ADDENDUM NO. 2

BID NO. 2838

**CLOVIS EAST HIGH SCHOOL CTE FARM AND FOOD PRODUCT FACILITY
CLOVIS UNIFIED SCHOOL DISTRICT
CLOVIS, CALIFORNIA**

G.A. PROJECT NO. 1739

S4.4

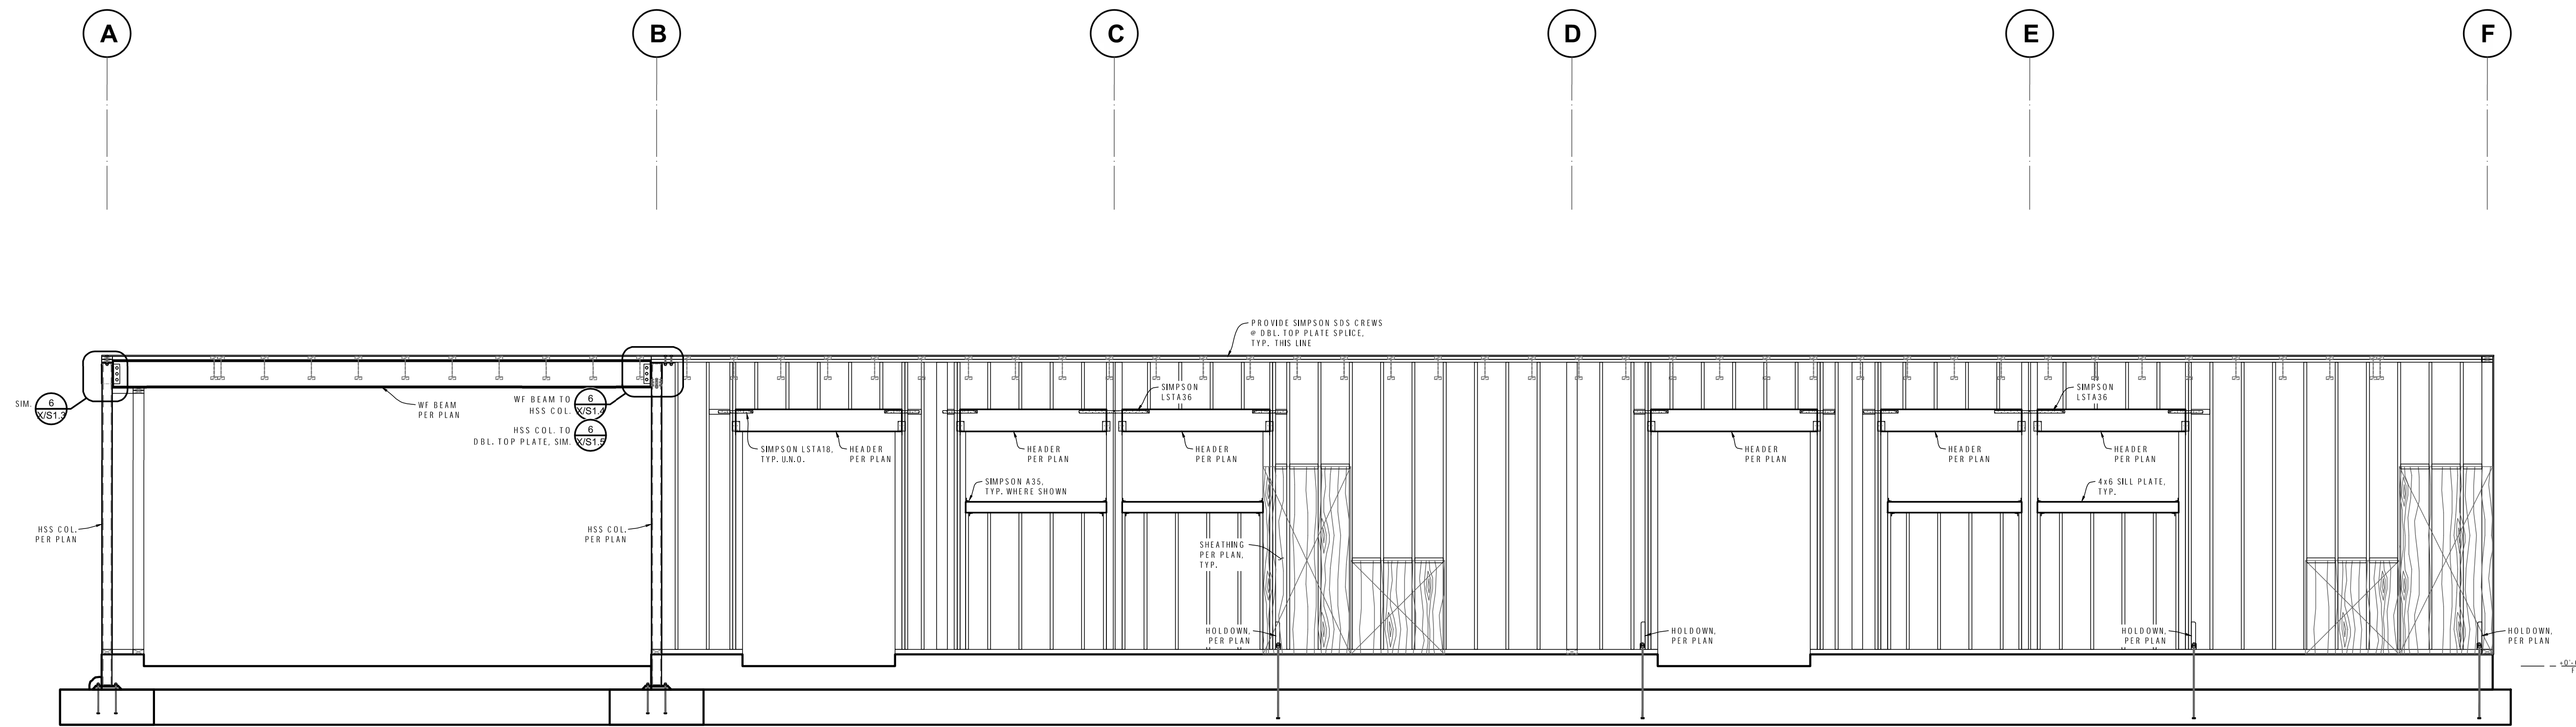
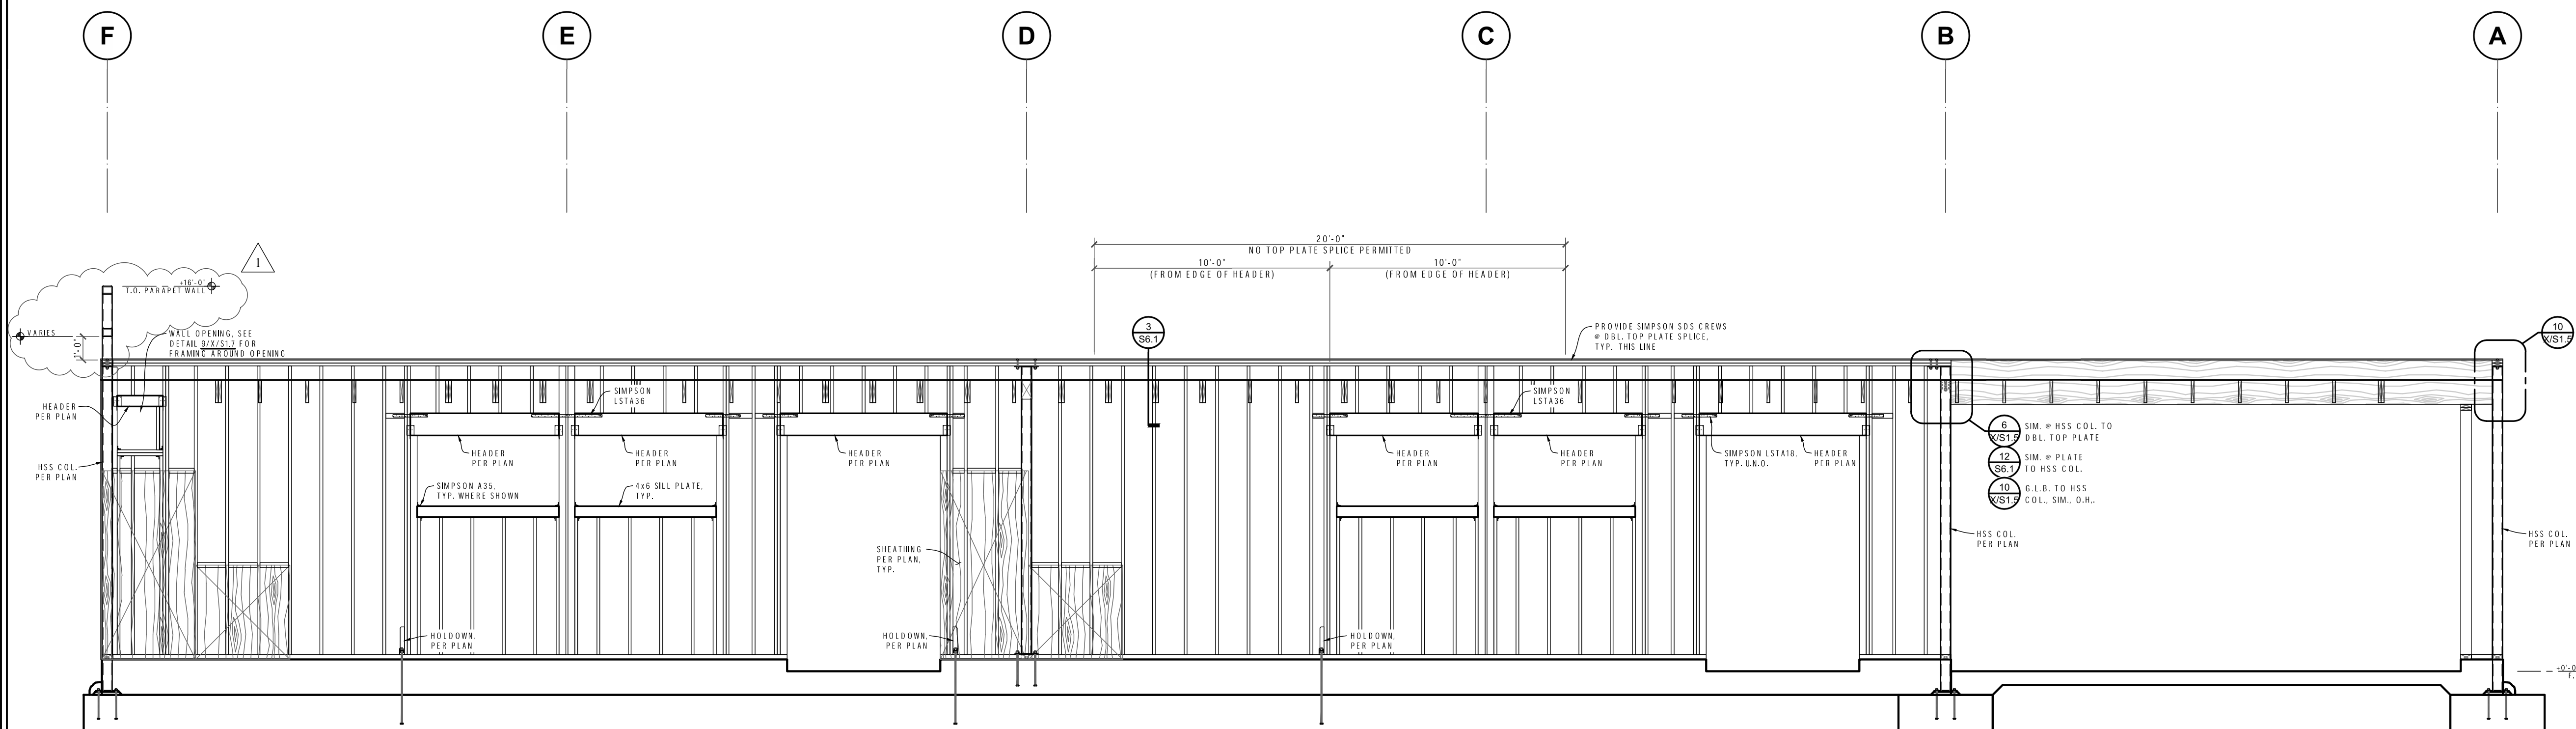
S4.4:

- 1.) Revised elevation to show screen wall.

S6.1

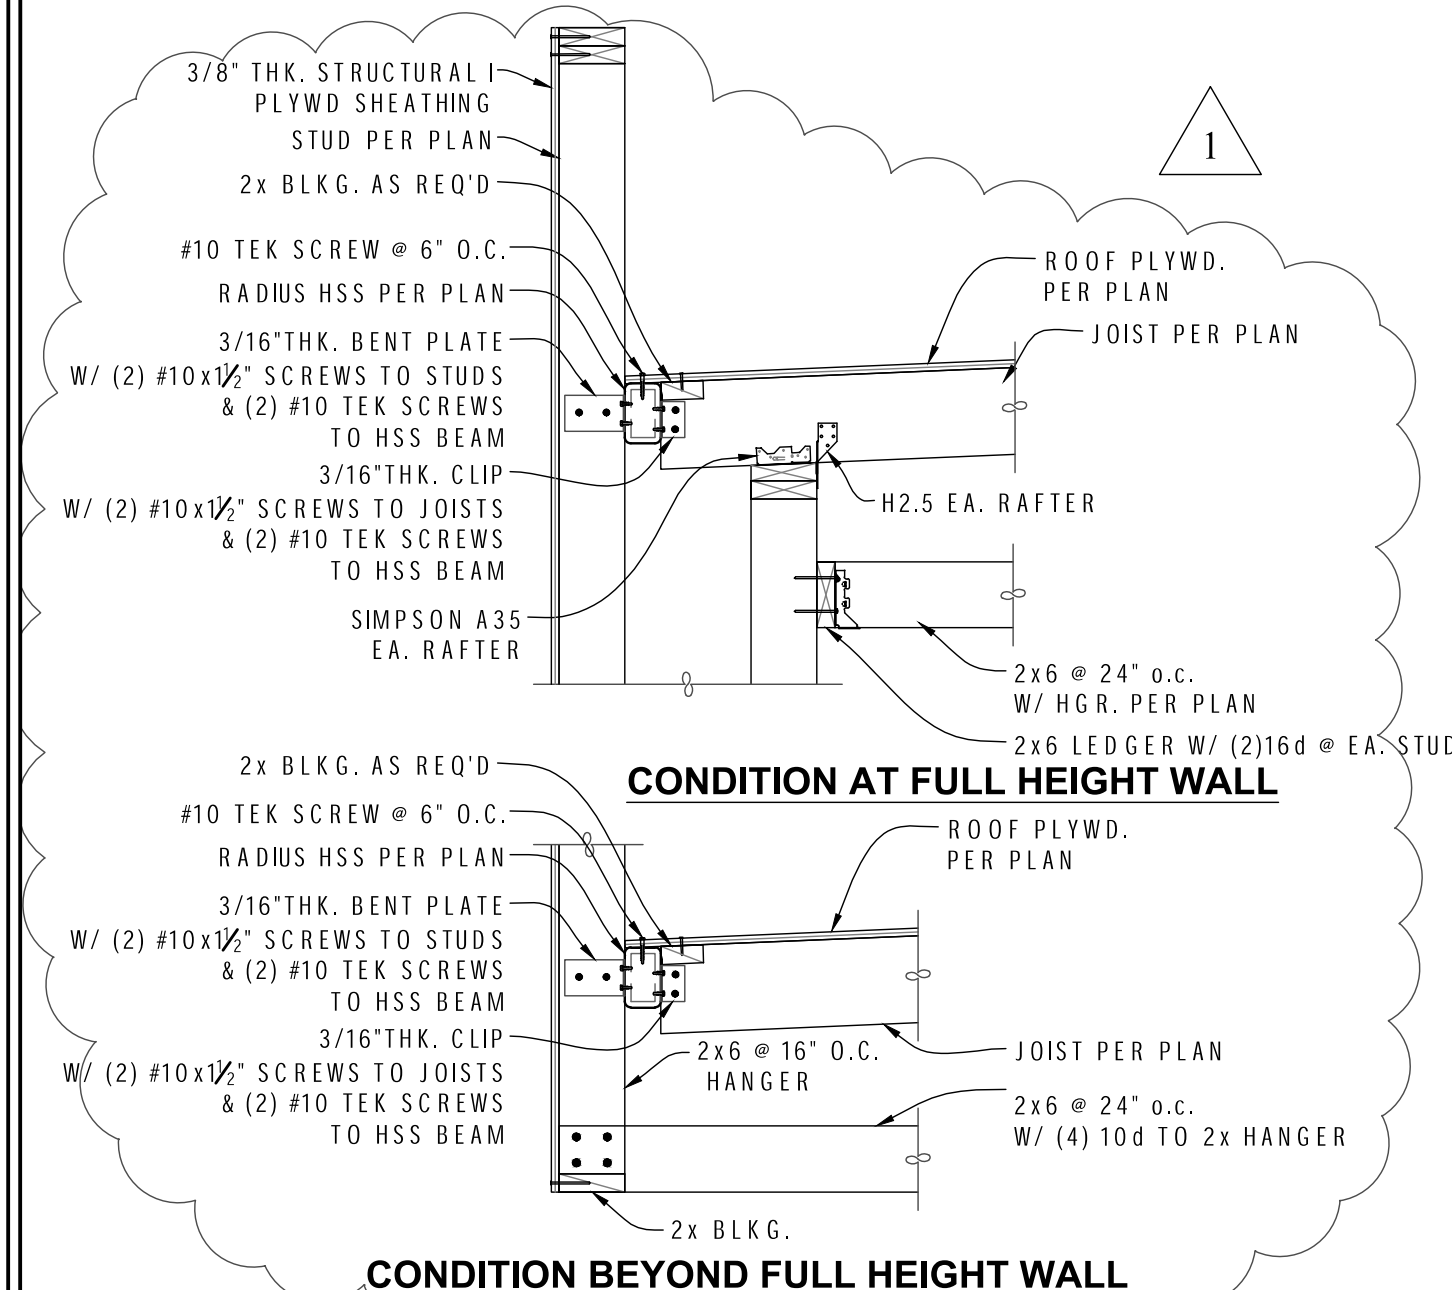
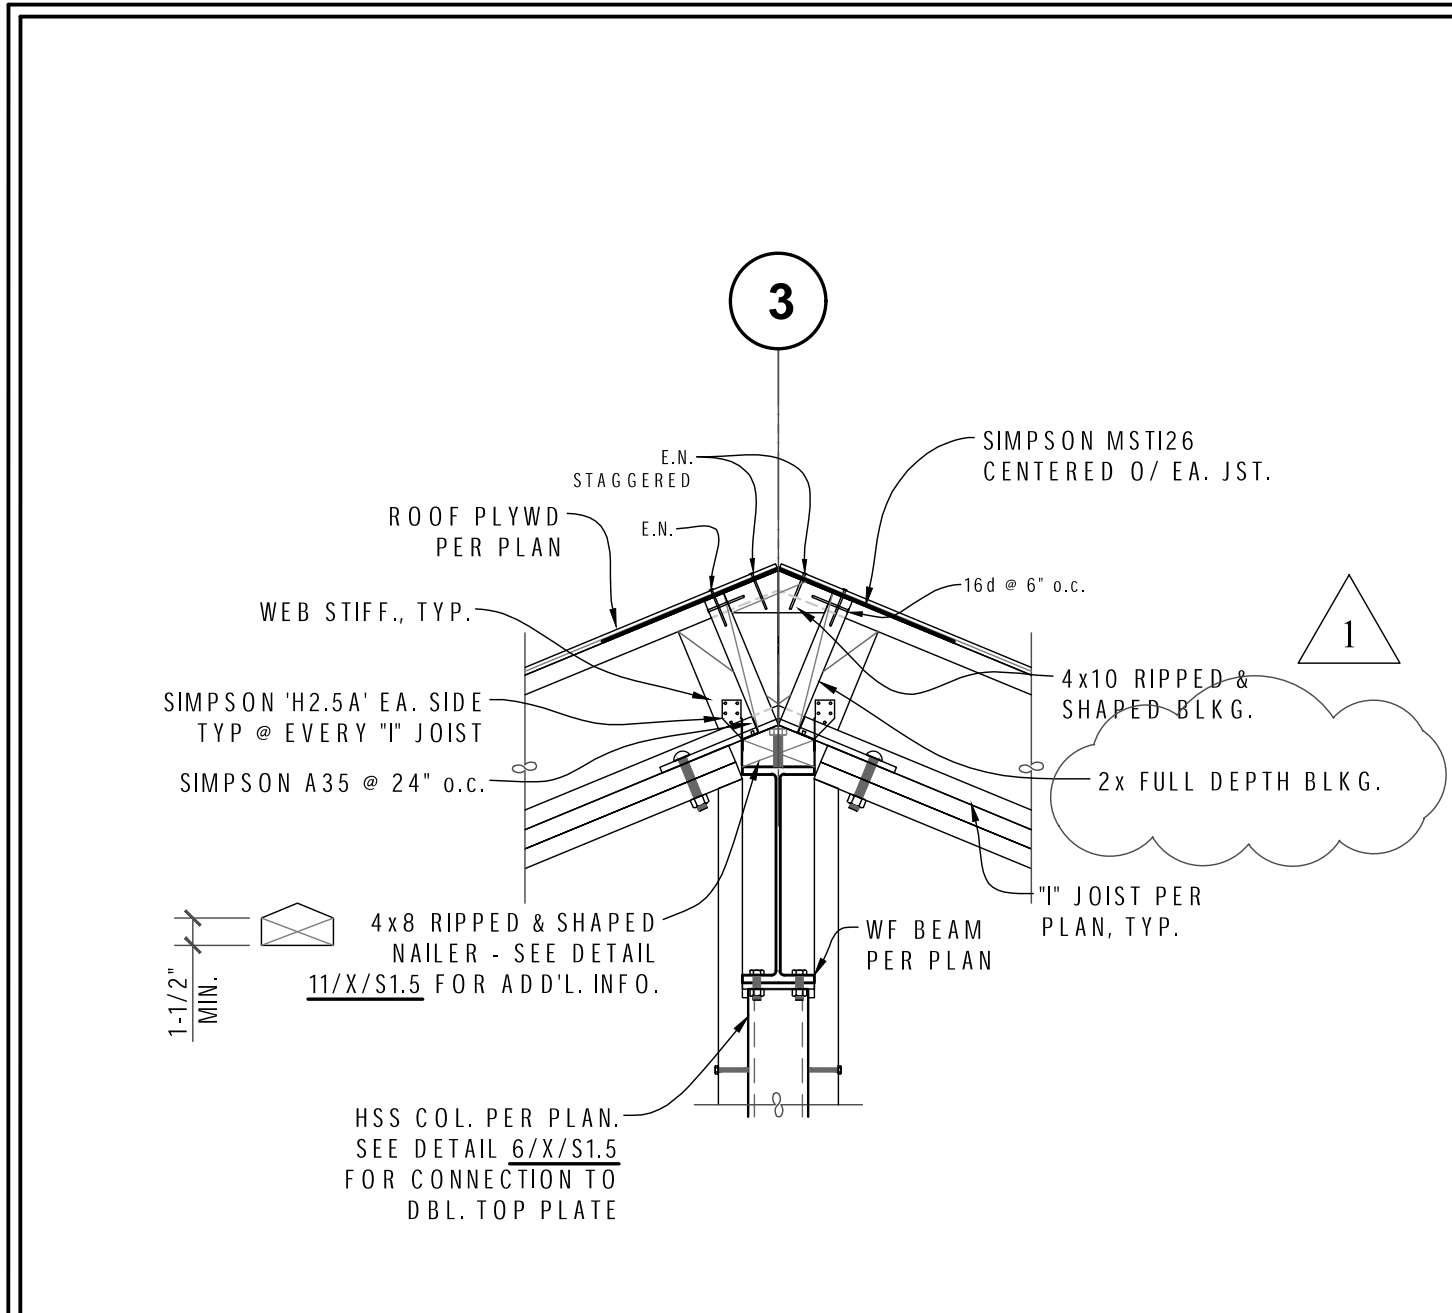
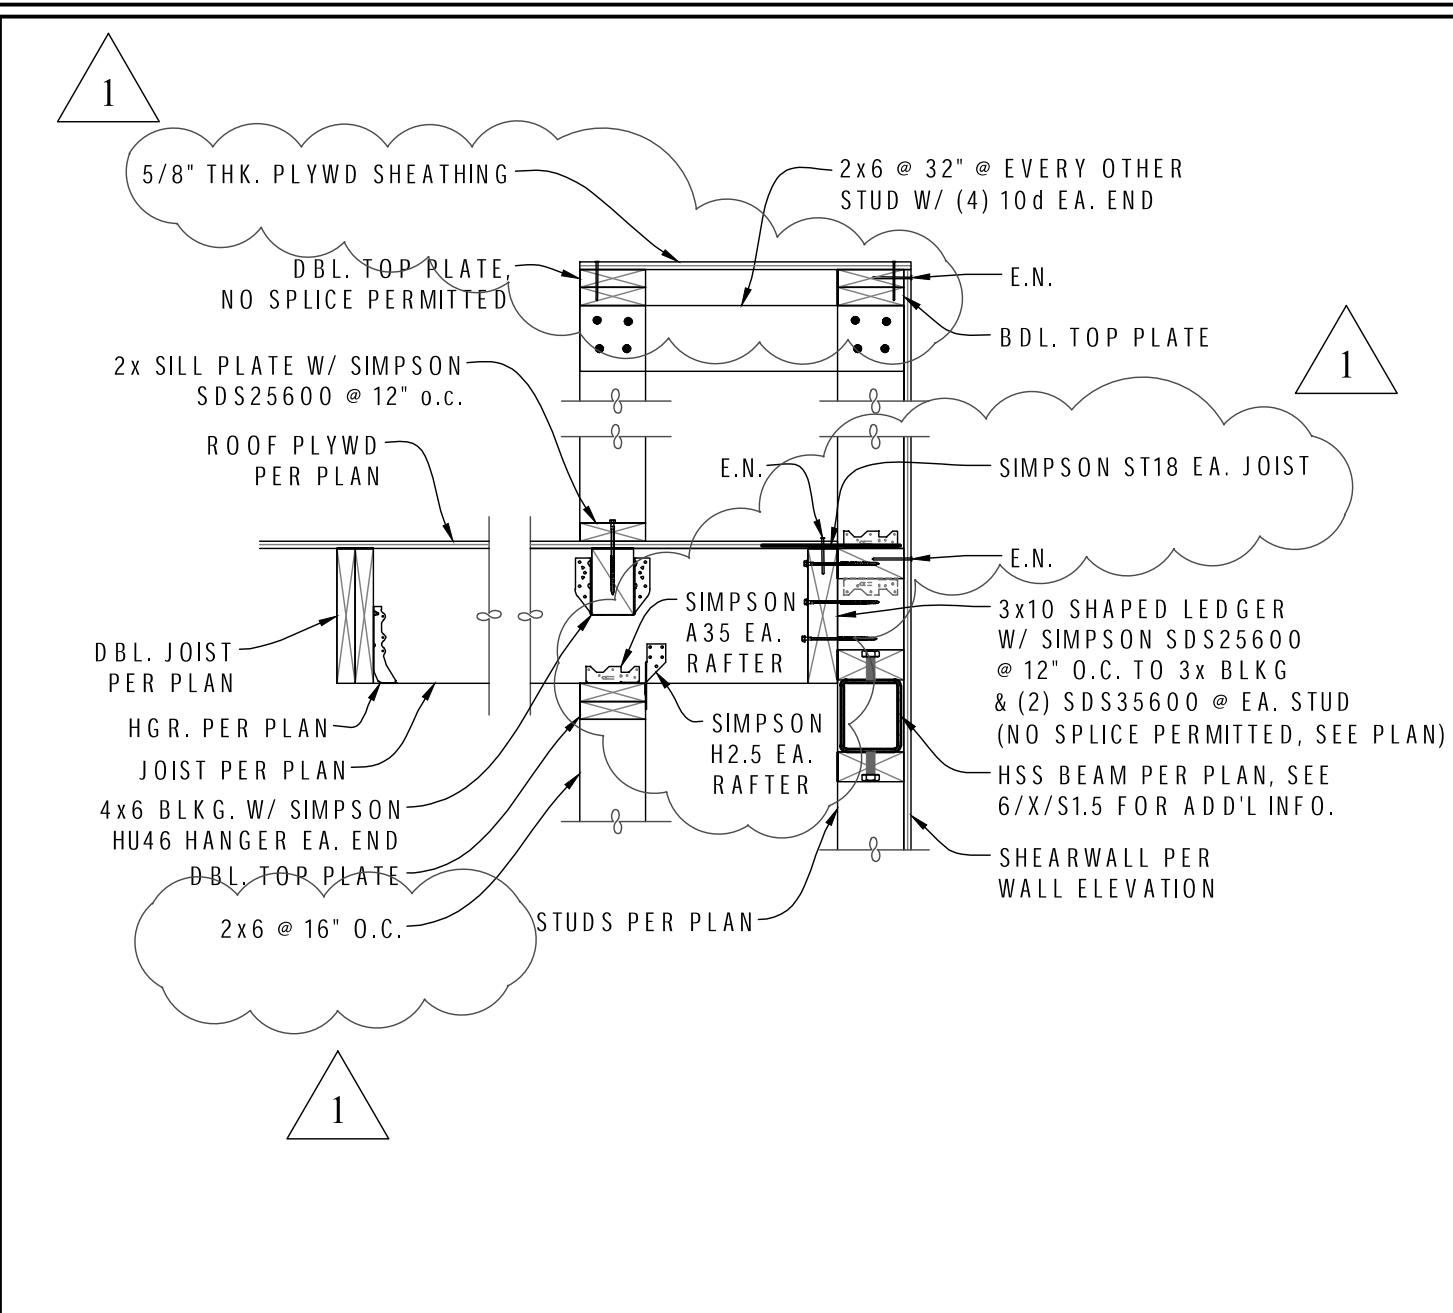
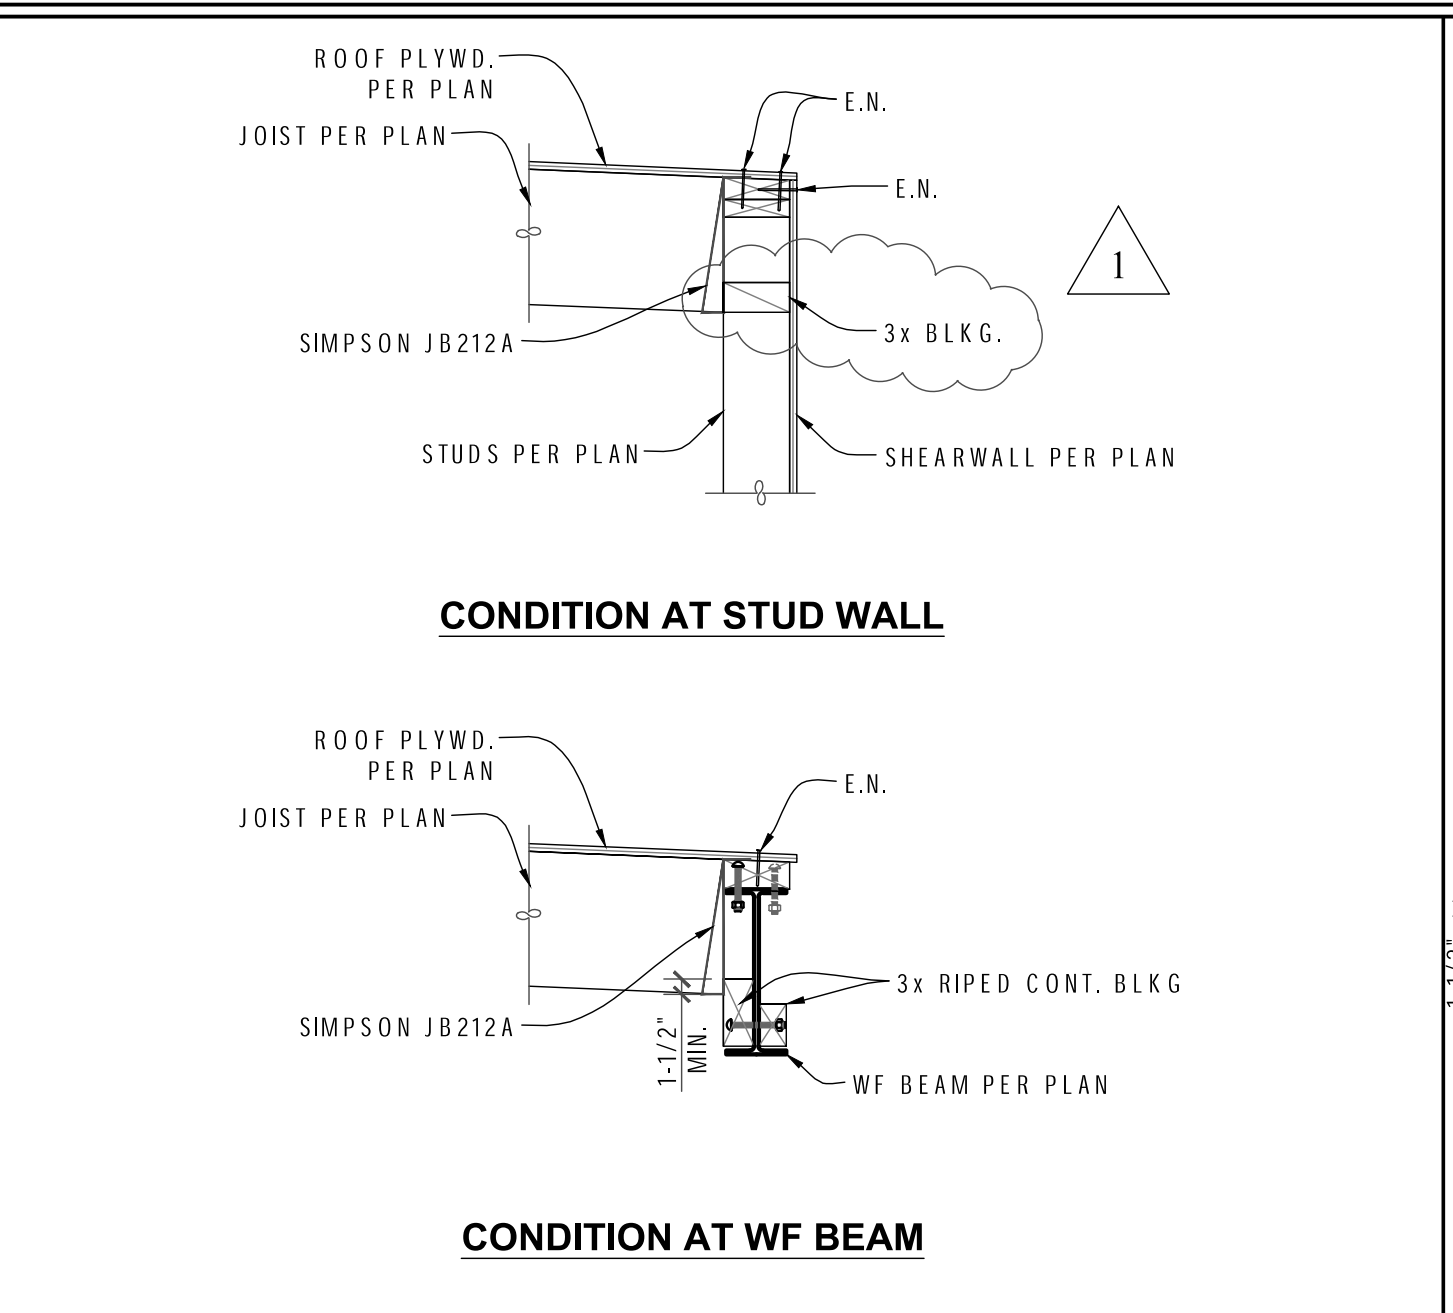
S6.1:

- 1.) Clarified and provided required 3X blocking.
- 2.) Clarified full depth blocking.
- 3.) Revised and clarified tie straps.
- 4.) Revised and clarified ledger Information and quantity of fasteners required.
- 5.) Provided additional blocking and nailing on detail 5.
- 6.) Provided cover sheathing @ parapet on detail 7.
- 7.) Revised and clarified detail 11.
